HISTORIC AND DESIGN REVIEW COMMISSION

HDRC CASE NO: 2023-184
ADDRESS: 419 FLORIDA ST
LEGAL DESCRIPTION: NCB 3008 BLK 6 LOT 13
ZONING: RM-4, H
CITY COUNCIL DIST.: 1
DISTRICT: Lavaca
APPLICANT: Nick Melde | Architexas
OWNER: Hamid Mizani | H2A Ventures
TYPE OF WORK: Rear addition roof form
APPLICATION RECEIVED: April 13, 2023
60-DAY REVIEW: Not applicable due to City Council Emergency Orders
CASE MANAGER: Bryan Morales

REQUEST:

The applicant is requesting an amendment to a previous Certificate of Appropriateness for approval to modify the roof form of the previously approved rear addition from a lower sloped shed roof to a steeply sloped shed form.

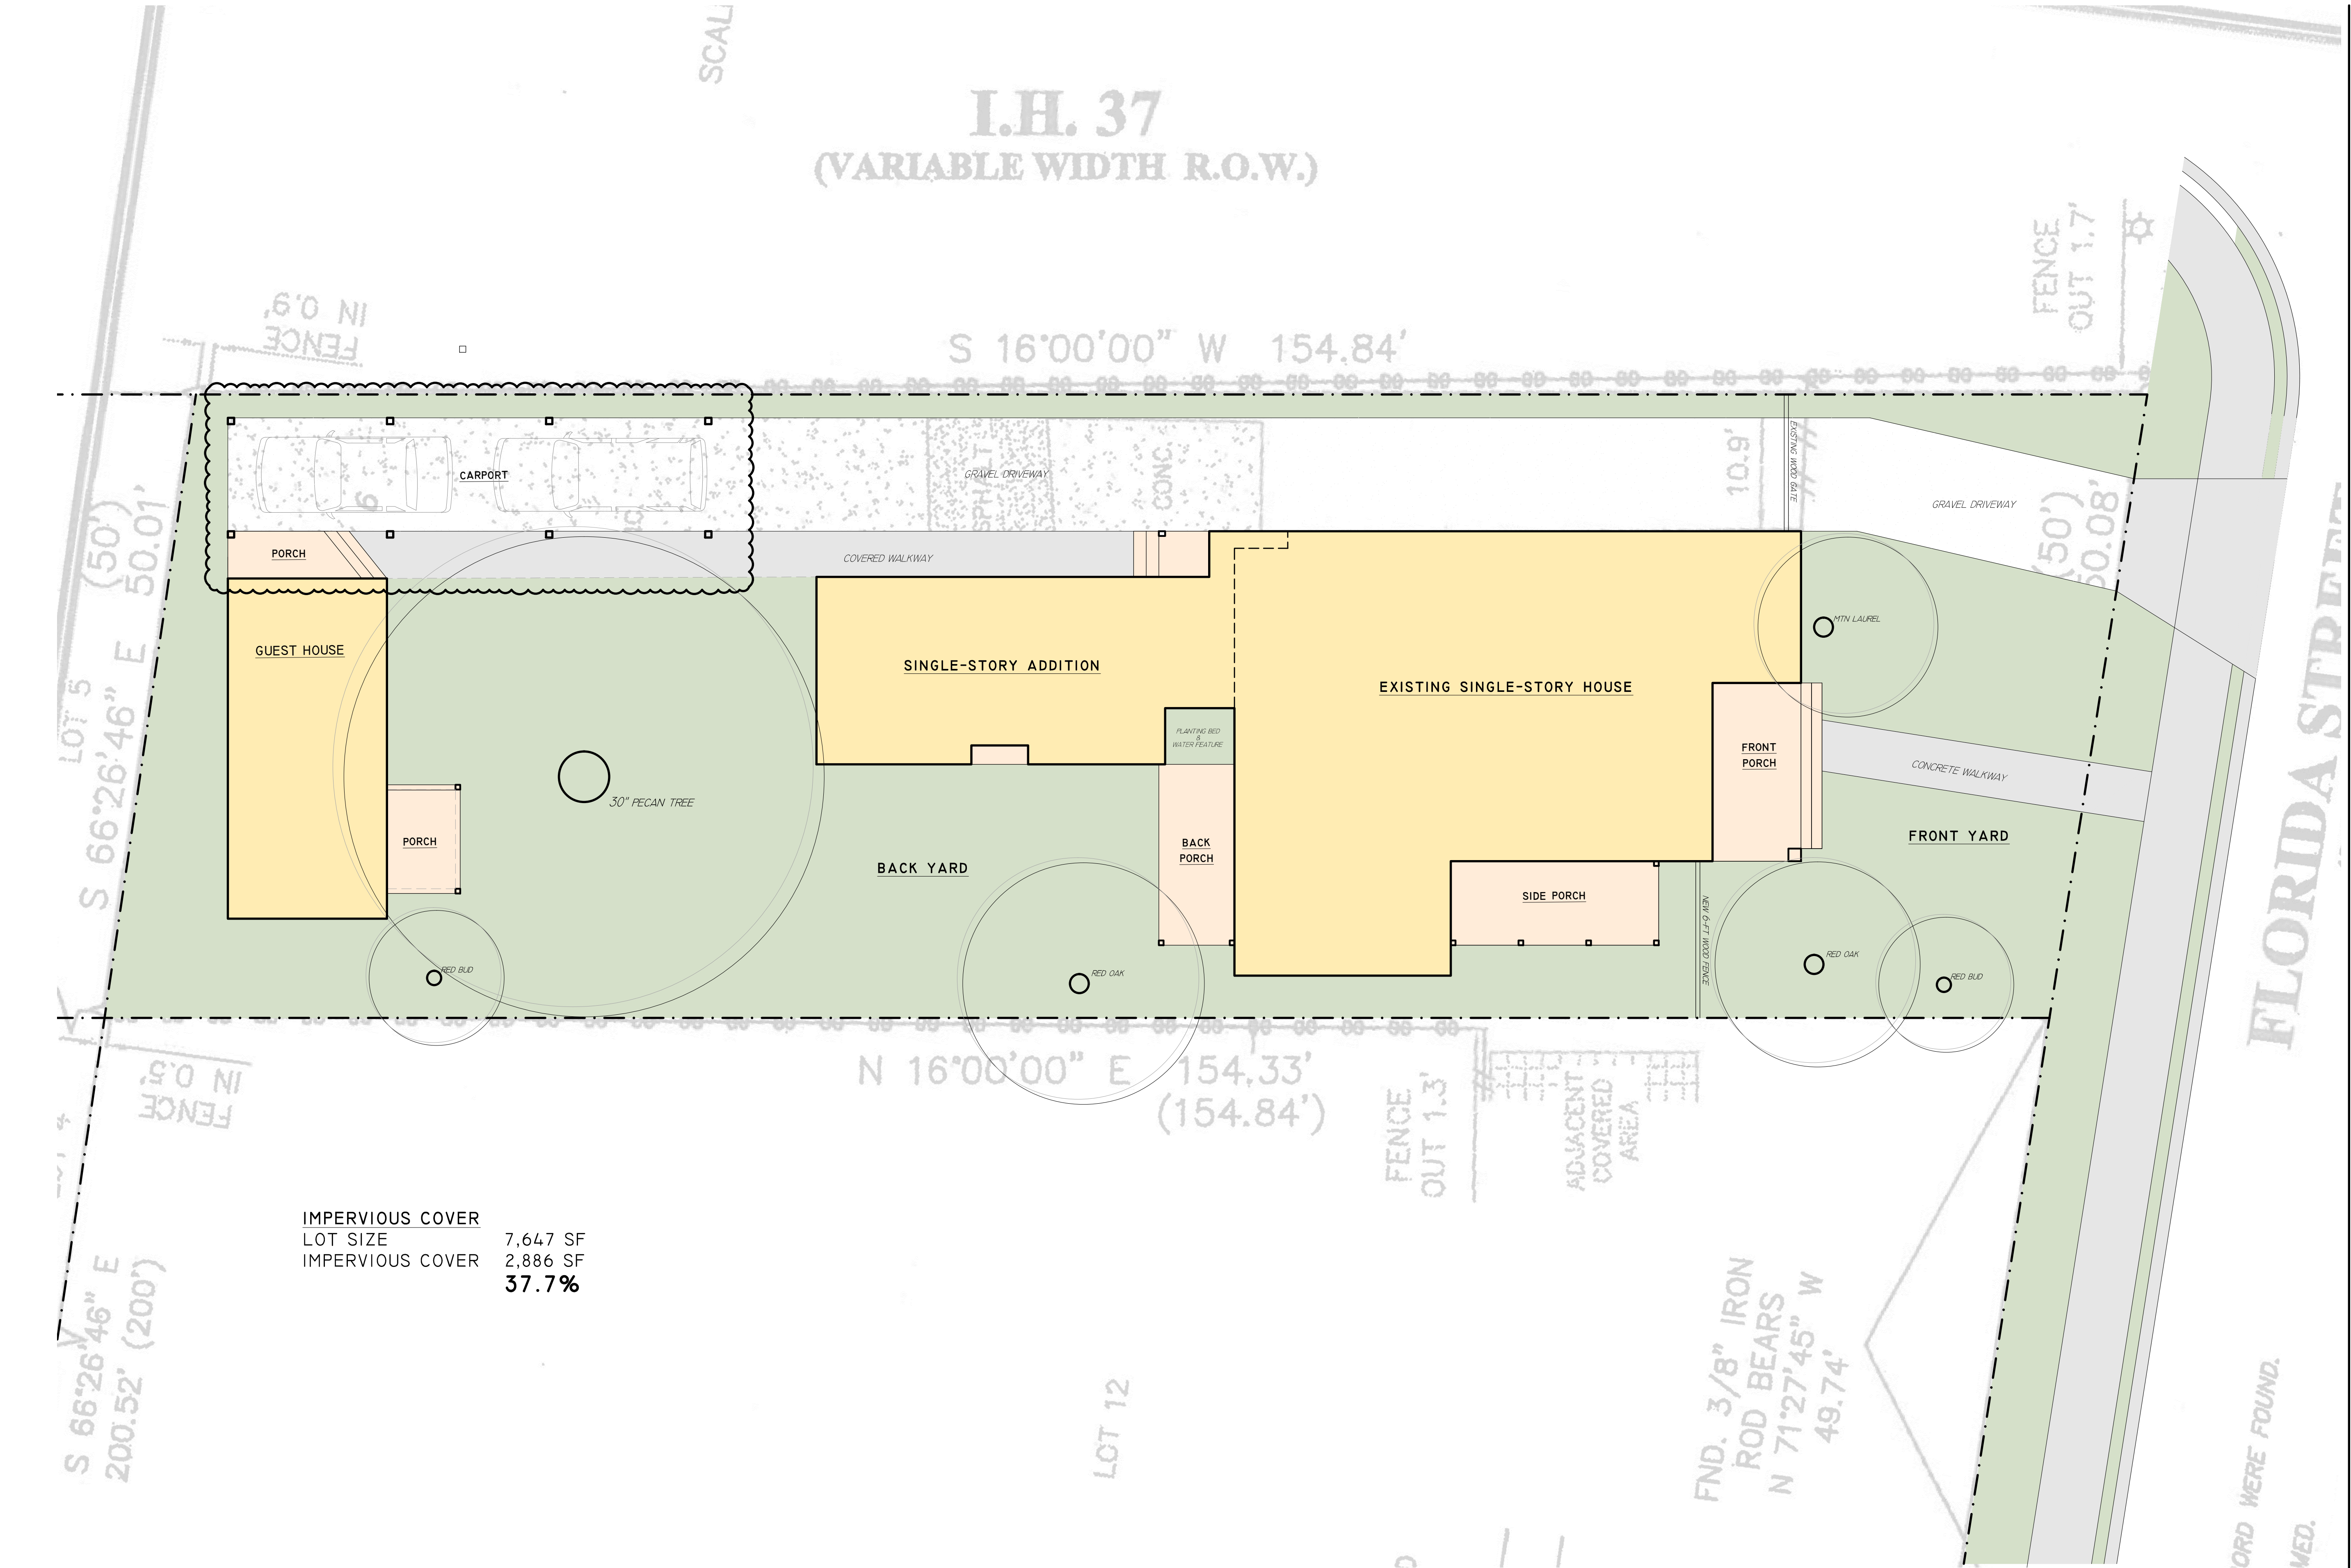
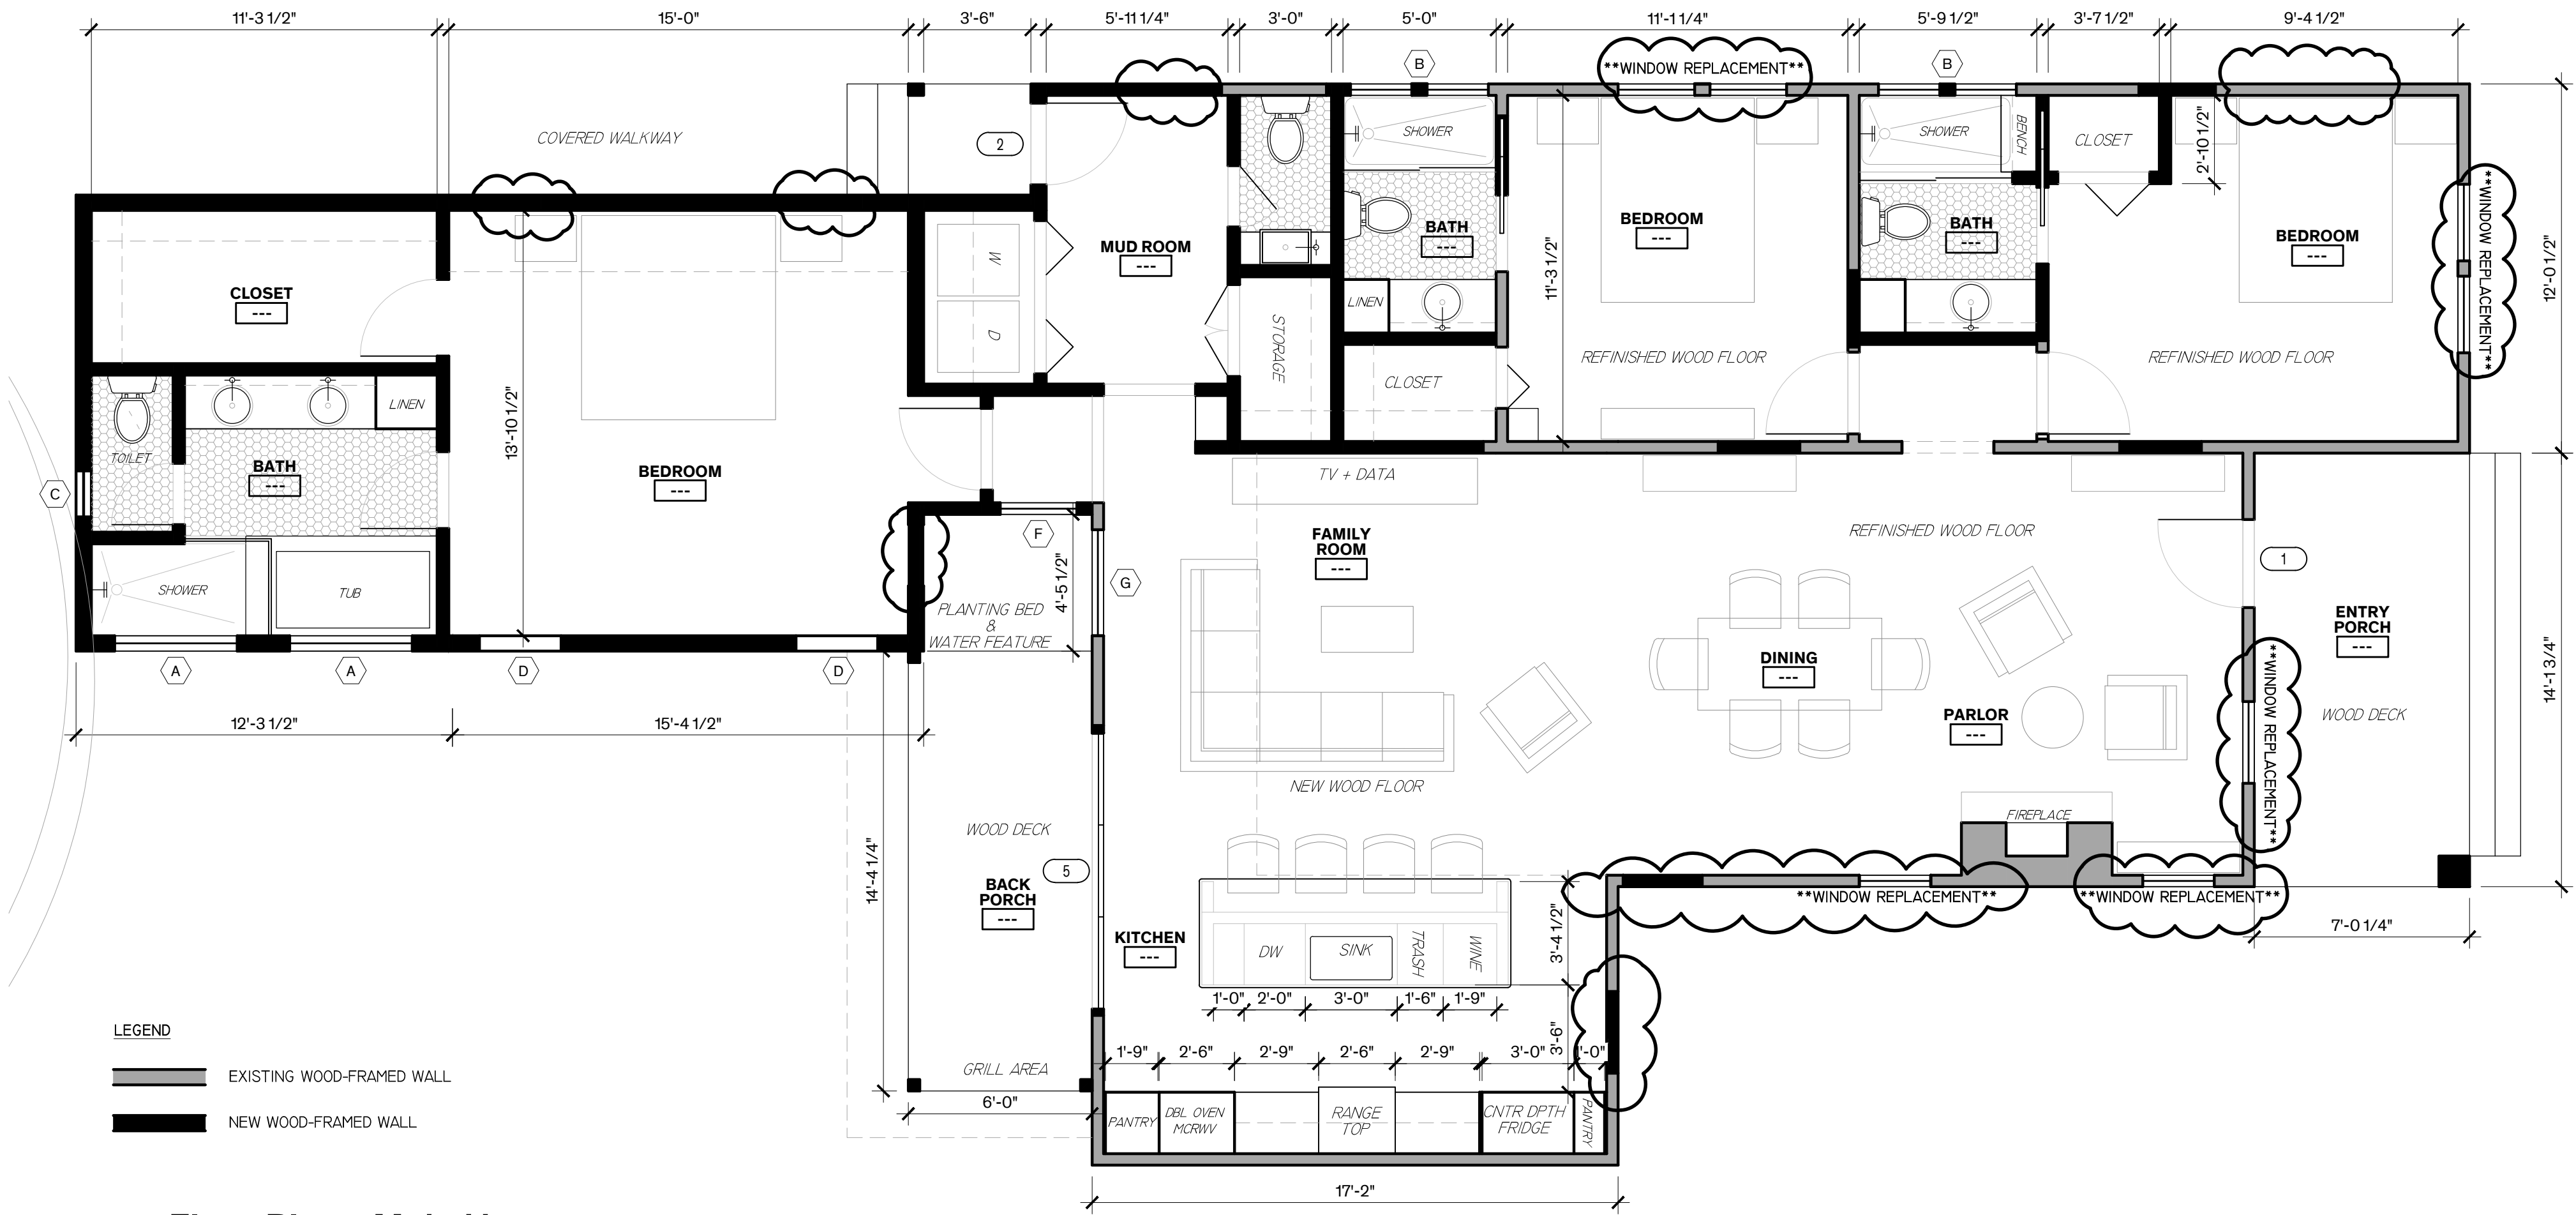
- c. SITE VISIT – Staff visited the site on May 10, 2023, at 4:00 PM and took photos of the addition's roof form. Staff finds that the roof pitch was not accurately represented on the updated construction documents and does not pose a problem for approval.

Staff recommends approval of the request, based on findings c and d.

Sheet Name
Proposed Exterior Elevations -
Main House

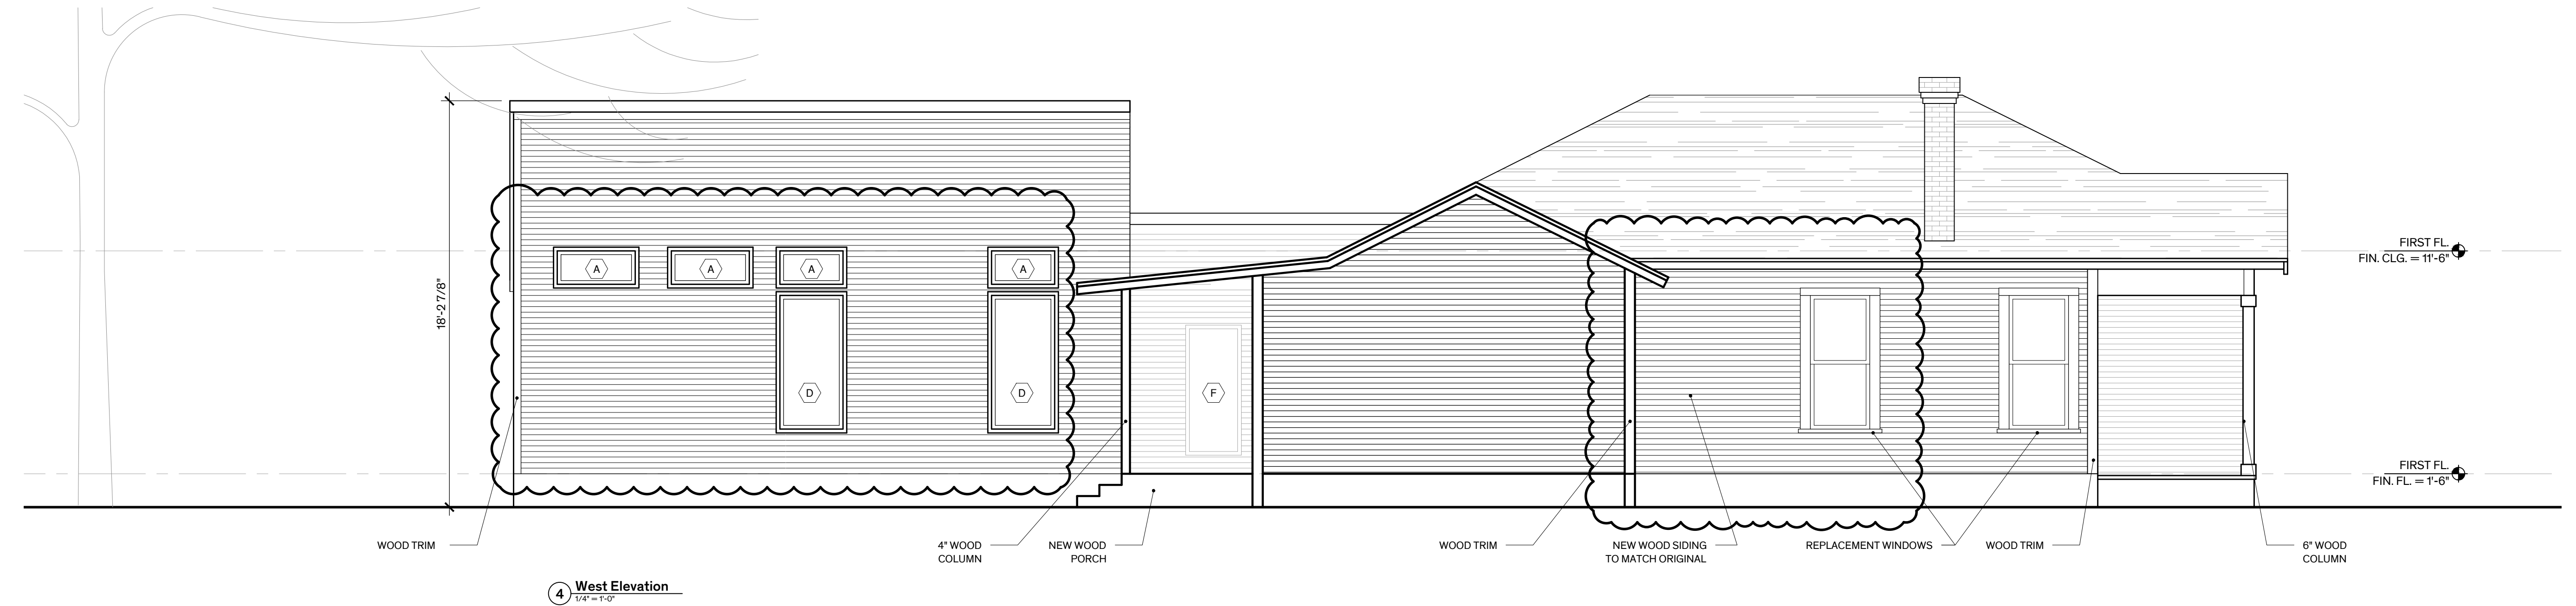
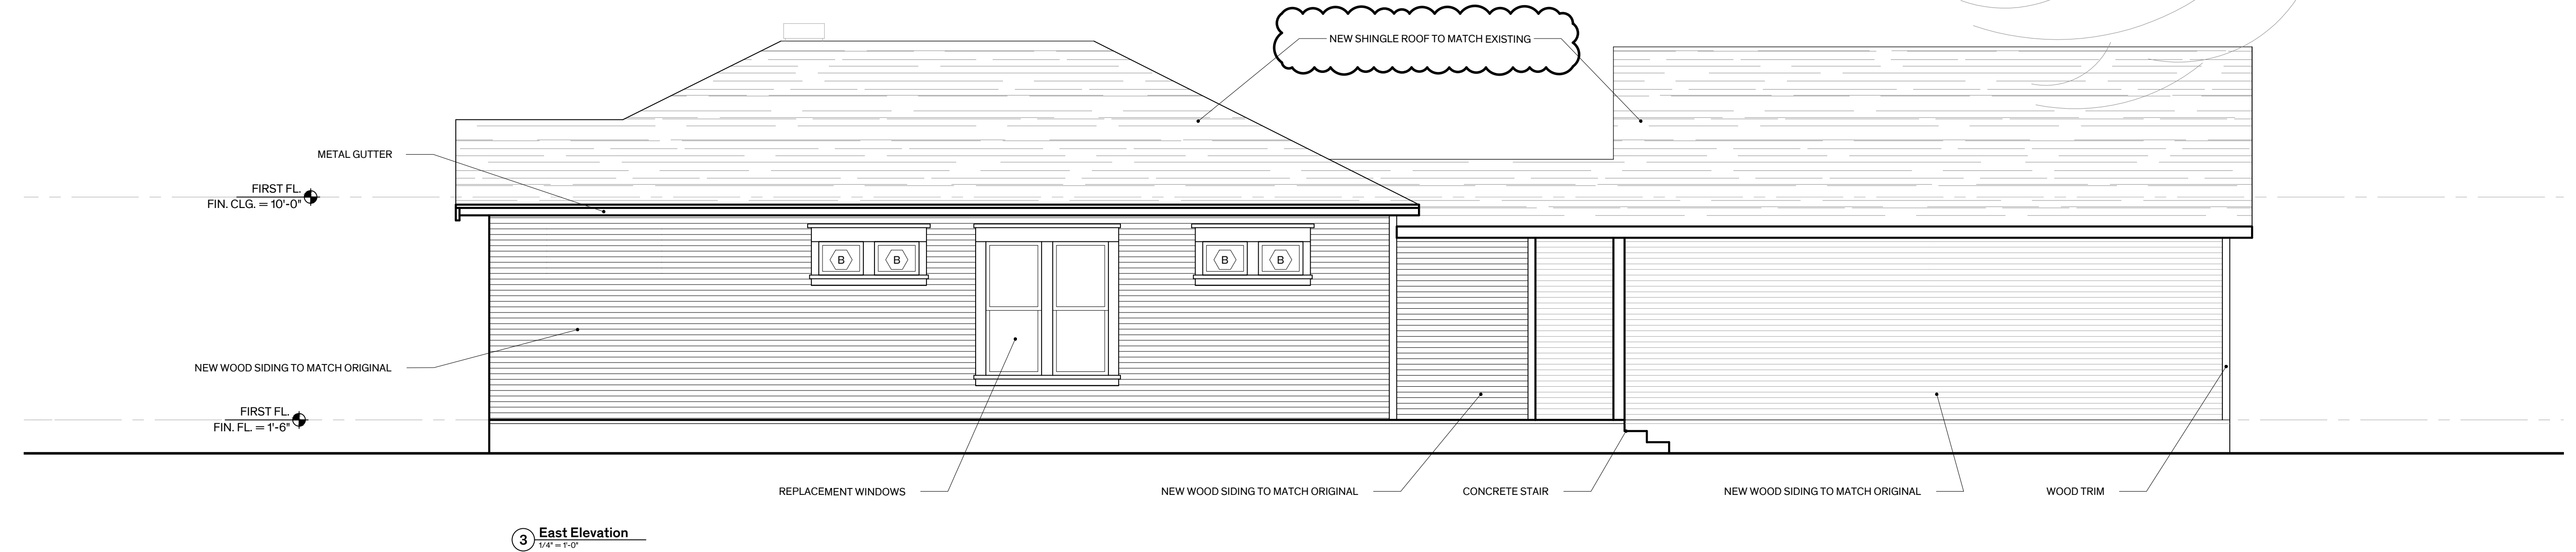
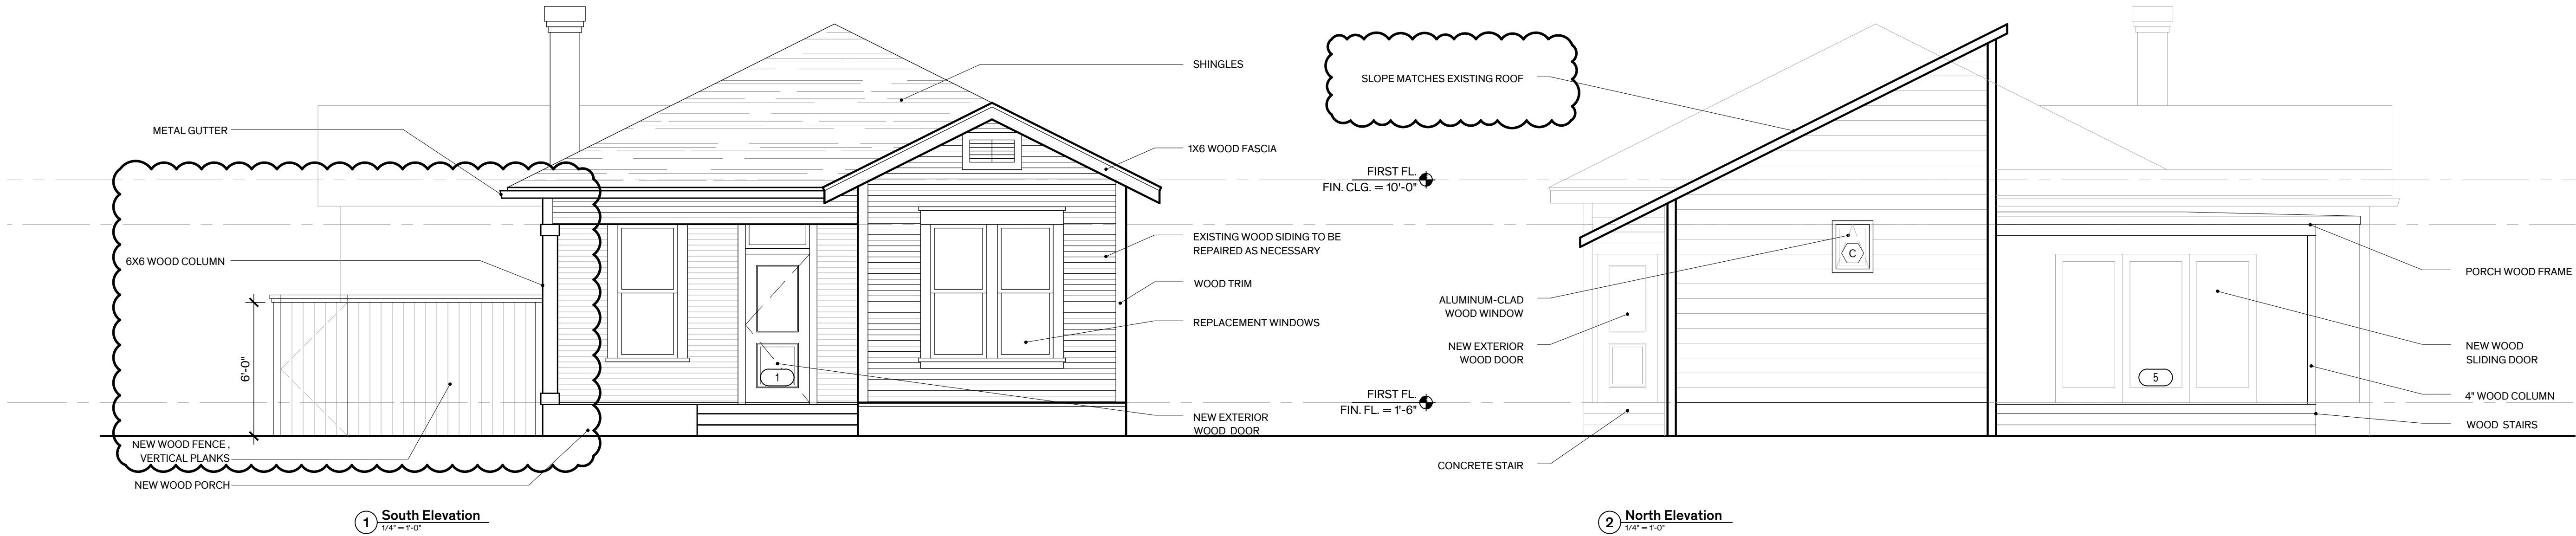
- d. ROOF FORM (ADDITION) – The applicant is requesting to modify their previously approved roof form of the rear addition by increasing the pitch of the shed form. The Historic Design Guidelines for Additions 1.A.iii. states to utilize a similar roof pitch, form, overhang, and orientation as the historic structure for additions. Additionally, Additions 1.B.i stipulates to design residential additions to be subordinate to the principal façade of the original structure in terms of their scale and mass. Staff finds the change in roof form generally conform to Guidelines.
